MC68VZ328

Addendum to MC68VZ328 Integrated Processor User's Manual (DragonBall™ VZ)

This addendum supplements, and should be used in conjunction with, the *MC68VZ328 Integrated Processor User's Manual*, rev. 0 (order number MC68VZ328UM/D). Section 1, "User's Manual Errata," corrects information in the user's manual, and Section 2, "Additional Information," provides supplemental information.

1.8.6 Corrections to Section 14.4.12, "UART 2 Miscellaneous Register"

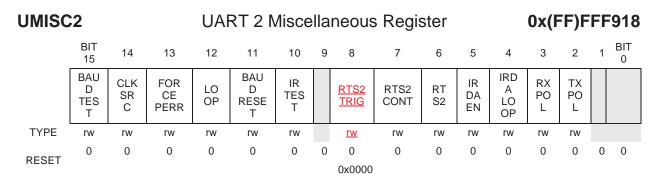
Bit 8 of this register is incorrectly represented as being reserved (page 14-26). It is the RTS2 TRIG bit. This correction affects the display of the UMISC2 register and Table 14-14.

In the display of the UMISC2 register, ignore the grey fill for bit 8. In the cell for the bit name abbreviation, insert RTS2 TRIG. In the TYPE row, insert rw. A corrected version of the register display follows, with the new information in red and underlined.
